From: Bratcher, Mike, EMNRD
Sent: Monday, February 09, 2009 10:06 AM
To: 'Bob Asher'
Cc: Jerry Fanning
Subject: Below Grade Tank Closure Request

RE: Flint GU #1 Battery
30-015-21933
Section 22, T18S-R26E
Eddy County, New Mexico

From: Bratcher, Mike, EMNRD
Sent: Monday, July 07, 2008 7:55 AM
To: 'jerryf@ypcnm.com'; 'boba@ypcnm.com'
Cc: Gum, Tim, EMNRD
Subject: Below Grade Tank Closure Requests

EXHIBIT
Sample Diagram (Not to Scale)

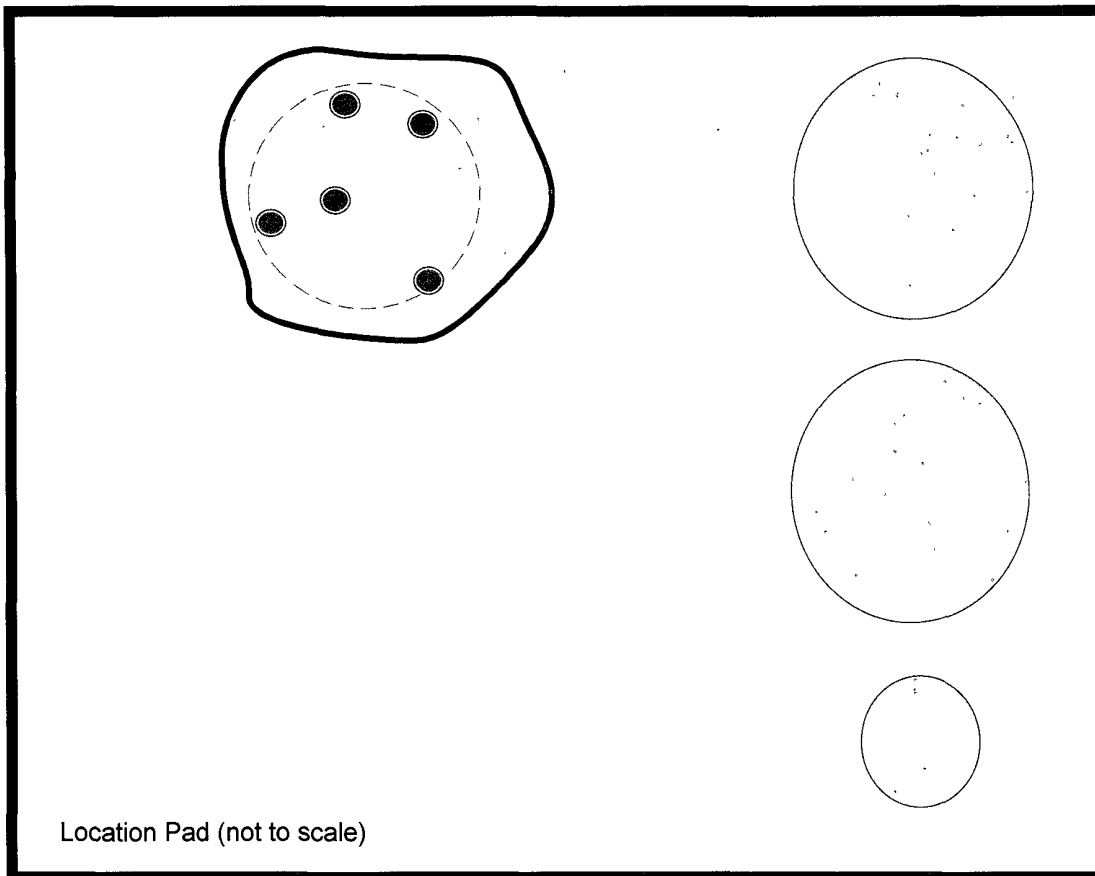
Additional delineation sampling has been performed, enclosed are analytical results that indicate decreasing levels on chlorides. Approximately one (1) foot of materials from the sides and bottom were removed and taken to an OCD approved facility. Yates Petroleum Corporation requests installation of a cap prior to backfilling excavation and closure of the below grade tank site.

EXHIBIT
Sample Diagram (Not to Scale)

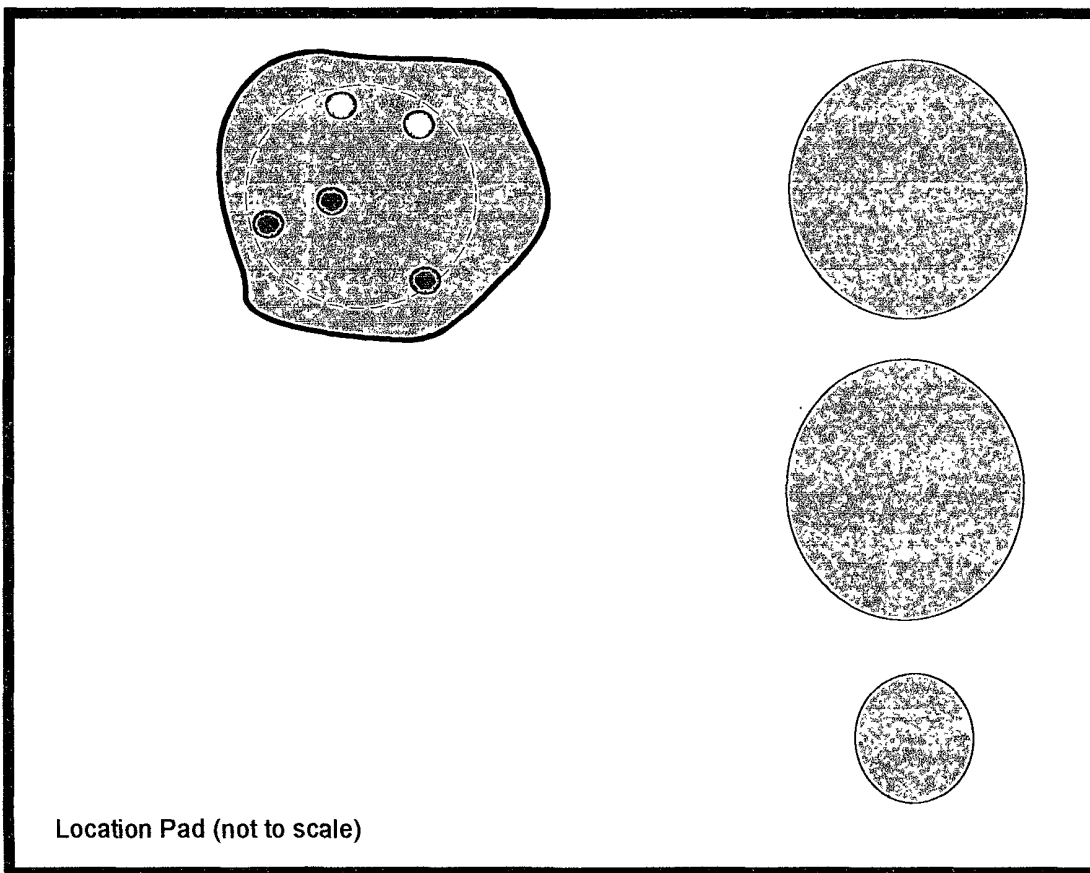
EADS GA Btry	30-015-21788	N-22-18-26	Chloride contamination level increase in bottom samples at 1' to 2' depth. Additional samples required to delineate contamination.
Flint GU 001 Btry	30-015-21933	J-22-18-26	Chloride contamination level increase in bottom samples at 1' to 2' depth. Additional samples required to delineate contamination.
			Removal of 1' of material as proposed is approved to address hydrocarbon contamination.
Len Mayers 001	30-015-05926	D-28-18-26	Chloride contamination level increase in bottom samples at 1' to 2' depth. Additional samples required to delineate contamination.
Gates AAC Btry	30-015-24931	C-22-18-26	Chloride contamination level increase in bottom samples at 1' to 2' depth. Additional samples required to delineate contamination.
Cannon FW Btry	30-015-21775	C-21-18-26	Chloride contamination level increase in bottom samples at 1' to 2' depth. Additional samples required to delineate contamination.
